Project Name	BCWD Permit 24-18 County Road 15B Grading	Date	1/3/2025
To / Contact info	BCWD Board of Managers		
Cc / Contact info	Jeremy Nielsen, PE / SRF Consulting Group		
Cc / Contact info	Ryan Hoefs / Washington County		
Cc / Contact info	Karen Kill, Administrator / BCWD		
From / Contact info	Paul Nation, PE; Julia Lau / EOR		
Regarding	Permit Application No. 24-18 Engineer's Report

Applicant: Washington County Highway Department

Recommendation: Approve with Conditions

Figure 1: Site Plan

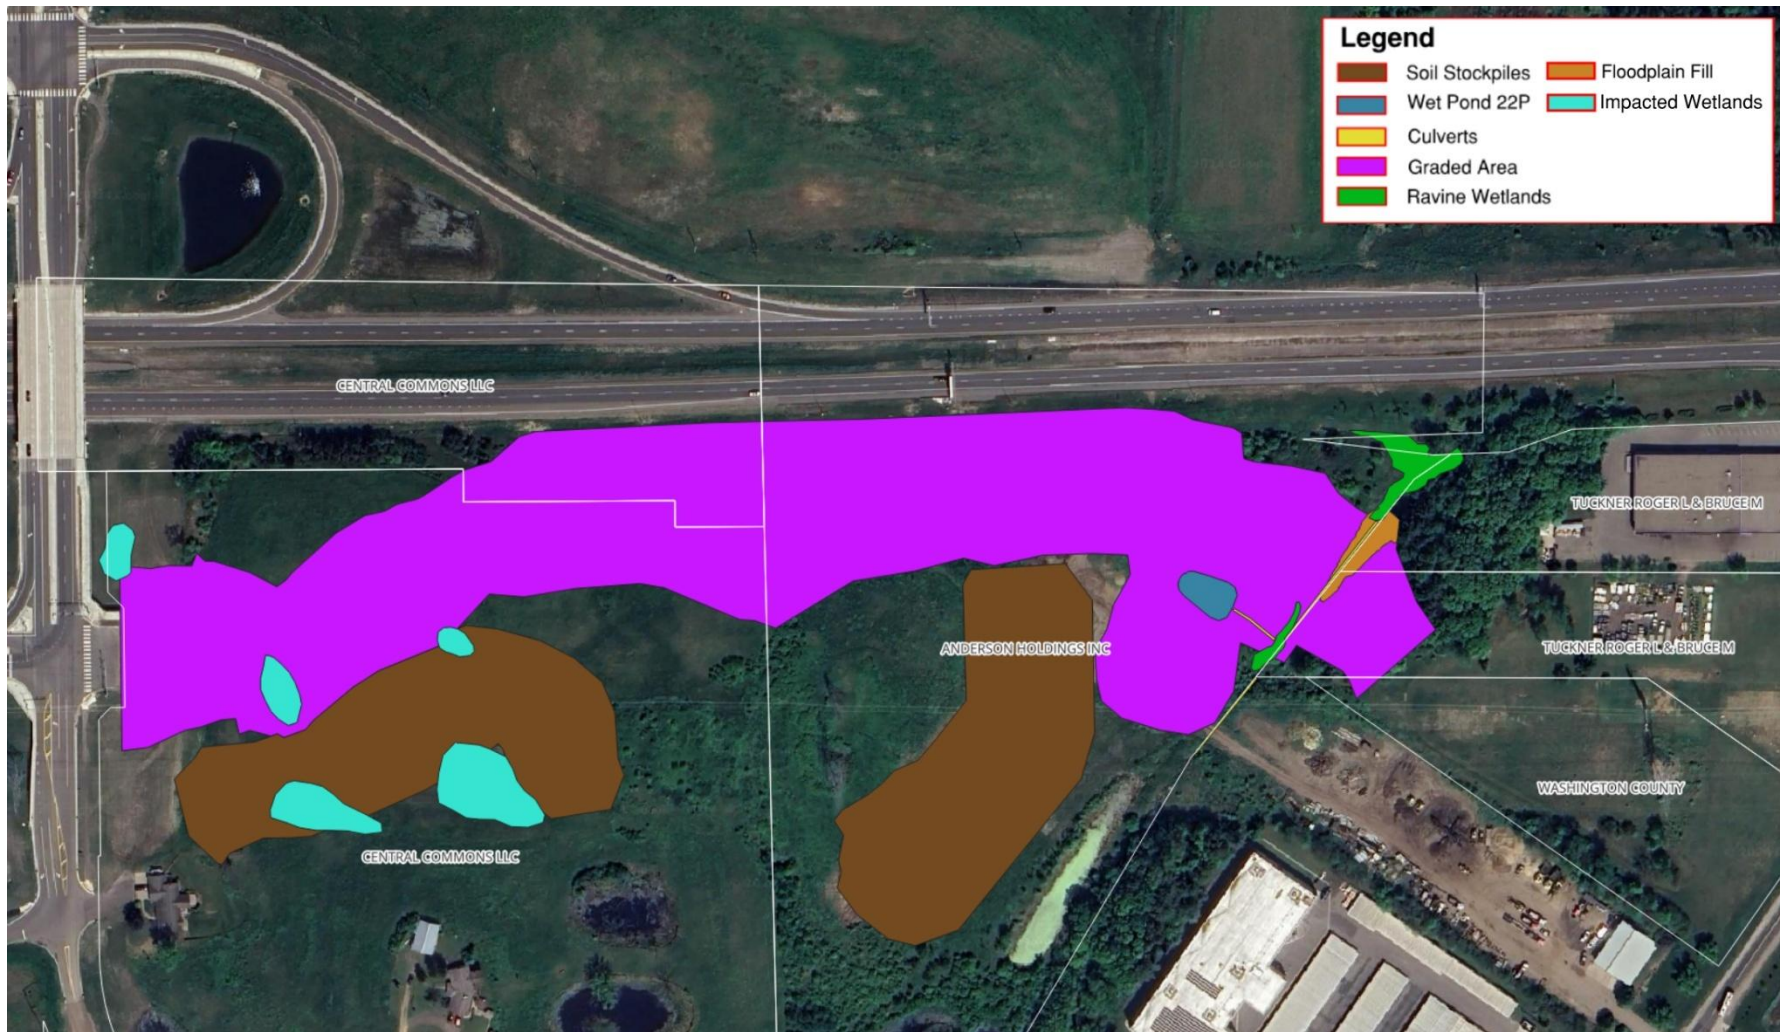
Washington County has applied to BCWD for a permit for grading across several properties needed to establish grades suitable for the future construction of County Road 15B from Manning Avenue east to a point 800 feet west of Memorial Avenue, and along and south of Trunk Highway 36. (See Figure 1.) The application, if approved, will authorize grading only; no road or other construction would be authorized.

In addition to the grading work, the county proposes to install a culvert and fill in the ravine in preparation for the future road construction, and a wet pond will be constructed for floodplain mitigation (Figure 1). The county has requested a variance from compliance with Rule 7.0 because the storage provided by the wet pond is not located within the ravine floodplain. The final Wetland Conservation Act approval of fill in two ravine wetlands within the proposed project area must be provided as a condition of permit approval. Wetland impacts for filling of wetlands on the Central Commons site were approved through WCA using state-approved mitigation credits. Central Commons LLC has authorized Washington County to rely on these approvals for the wetland fill related to the county's work on their property.

Recommendation: The BCWD engineer recommends that the board approve the application and determines that there is sufficient technical support for the managers' approval of the requested variance, with the conditions and stipulations stated below.

Figure 2: Large Wetlands with buffers South of Grading Site

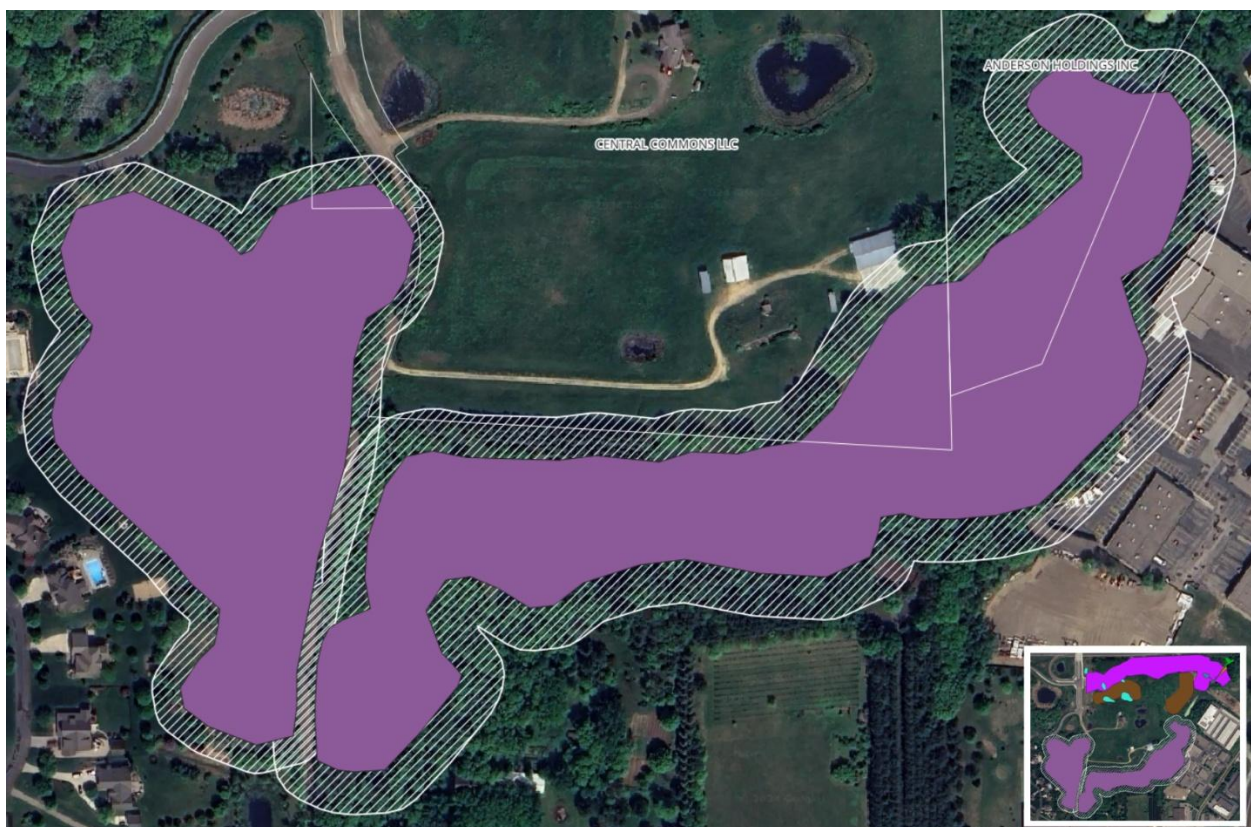
Rule 4.0 applies to the project because it is adjacent to two wetlands greater than one acre and the creation of right-of-way counts as subdivision of the property.

There are two wetlands larger than one acre located on the impacted properties, an 8.90-acre Manage 2 wetland (DNR Public Water 316W) on the Central Commons property and a 4.66-acre Manage 1 wetland located on both the Central Commons and Anderson Holdings properties (see Figure 2). The county asserts that it made a good faith effort to obtain rights to establish buffers for these wetlands. However, the buffers for these wetlands would be entirely outside of the right-of-way and therefore, not within the county's control. The required buffers must be established in the course of implementation of the work approved for Central Commons LLC permit 19-05. Anderson Holdings has indicated that it will complete a wetland delineation prior to any future development of its property and has verbally acknowledged the wetland buffer requirement.

Figure 3: Floodplain Fill and Replacement Storage at Wet Pond 22P

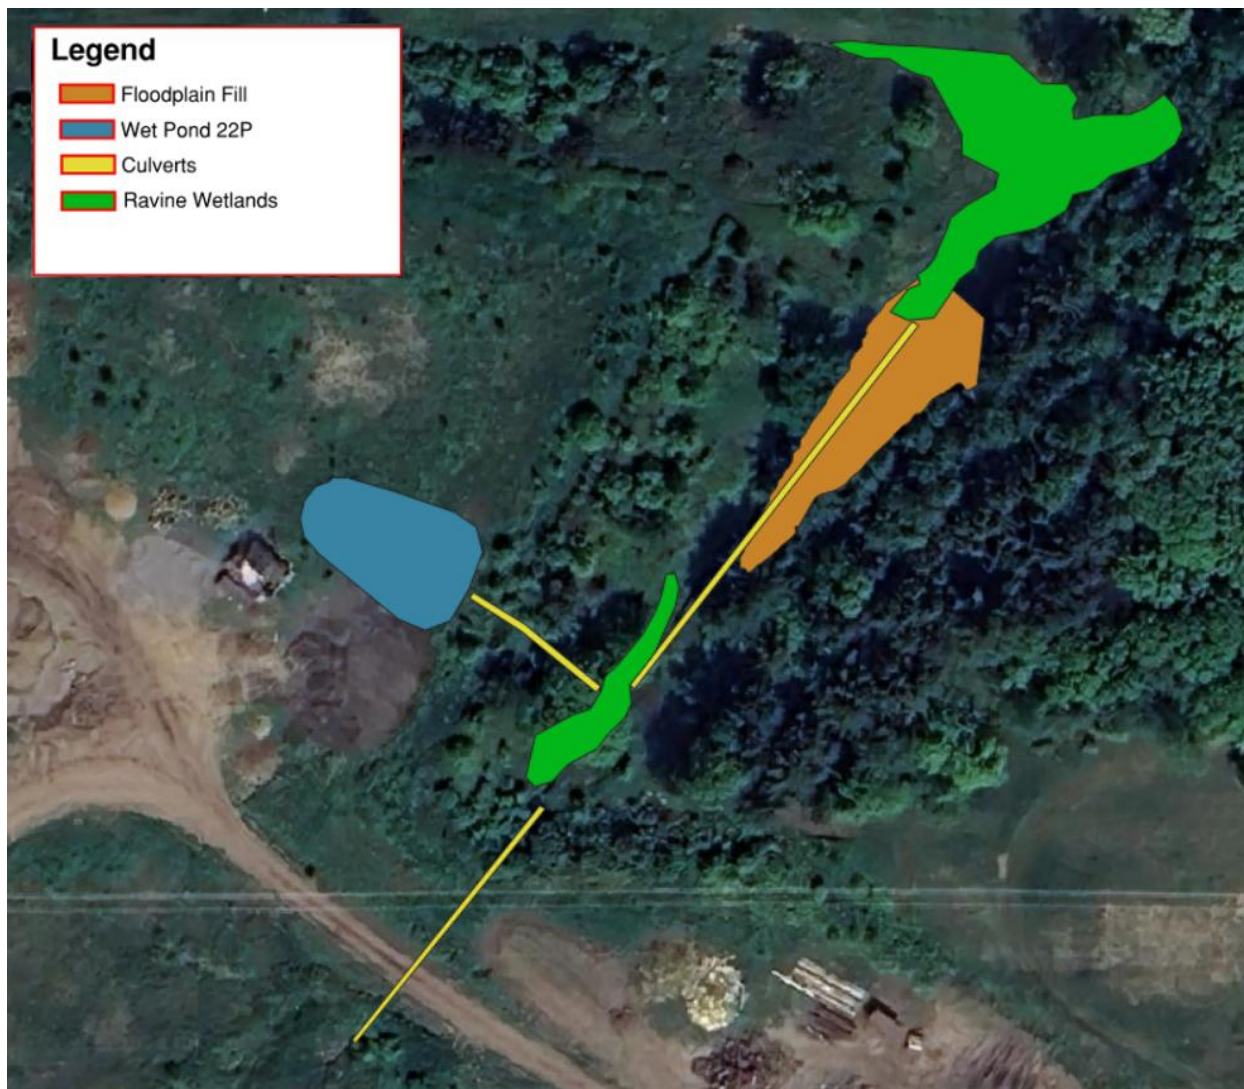
The applicant asserts, and the BCWD engineer concurs, that it is infeasible to provide replacement floodplain storage adjacent to the impacts on the Central Commons property, as additional impacts are anticipated once Permit 19-05 is issued and the work approved thereunder proceeds. Any replacement flood volume on this property would be lost once development occurs.¹ Instead, replacement flood volume is provided in the proposed wet pond. HydroCAD modeling demonstrates that 100-year HWLs on the large southern wetlands (the two requiring buffers as noted previously) will be reduced or maintained at existing conditions. These wetlands are downstream of the Central Commons wetlands to be filled (8P, 14P, 20P, 21P, and 23P), but upstream of the proposed wet pond (22P). The proposed wet pond will have a storage volume of 1.330 ac-ft. Redirection of water to the wet pond, instead of to the two large southern wetlands will help to offset the wetland fill, as shown in Table 1.

The applicant asserts, and the BCWD engineer concurs, that it is infeasible to provide replacement floodplain storage within the ravine due to the existing steep slopes and impacts additional grading would have on the adjacent landowners. As noted above, redirection of water to the wet pond, prior to discharging to the ravine, provides replacement floodplain storage. The location of the wet pond, relative to the floodplain fill in the ravine, is shown in Figure 3 below.

Since replacement floodplain storage is provided in the proposed wet pond and not within the floodplain of impacted wetlands, the applicant is requesting a variance to Rule 7.3.1, which is discussed under Rule 10.0.

Although the replacement of floodplain storage is not between the ordinary water level and the 100-year flood elevation (as defined in Rule 7.3.1) for the Central Commons wetlands or the ravine wetlands, the replacement flood storage exceeds the volume of floodplain fill as noted in Table 1. The variance will meet the intent of the rule by providing the same volume of storage and will not result in negative upstream or downstream impacts as noted above under Rule 7.0. The BCWD engineer determines that there is sufficient technical support for the managers' approval of the requested variance.
